National Park Service
Comments on the Basin Electric—Dry Fork Power Plant
Prevention of Significant Deterioration Permit Application
March 28, 2007

Basin Electric Power Cooperative (BEP) proposes to construct and operate a new 440 (gross) MW pulverized sub-bituminous coal-fired Dry Fork power plant near Gillette, WY. The proposed site is about 180 kilometers northwest of Wind Cave National Park (NP), and about 220 kilometers northwest of Badlands NP, both Prevention of Significant Deterioration (PSD) Class I areas administered by the National Park Service (NPS). Class II areas within 300 km and also administered by NPS include Devil's Tower National Monument (65 km), Mt. Rushmore National Memorial (146 km), and Jewel Cave National Monument (150 km).

Figure 2. PC Comparisons

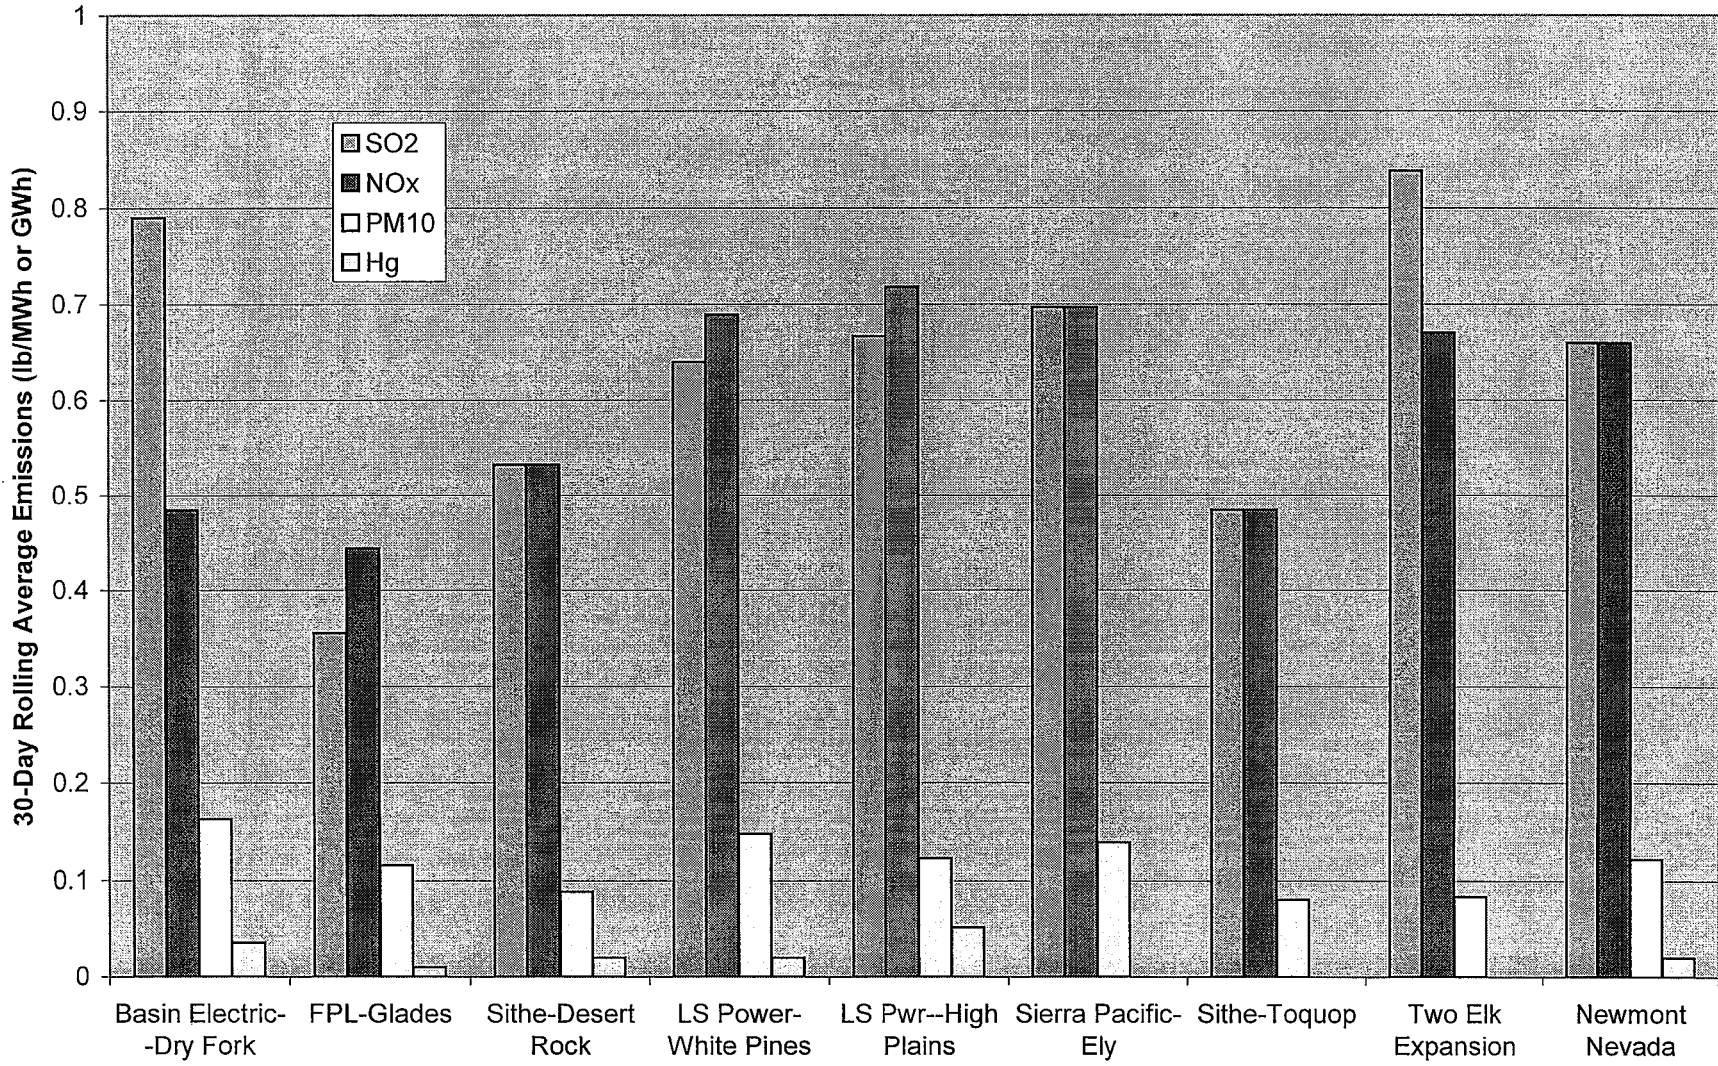
Figure 2 (attached) illustrates the differences in emissions among the proposals discussed above. It can be seen that, on an emission-per-energy output basis, Dry Fork would emit significantly more SO₂, PM₁₀, and mercury than other PC boiler projects. In summary, we believe that the Dry Fork facility could achieve lower SO₂, PM₁₀, H₂SO₄, and mercury limits than currently proposed in the application.
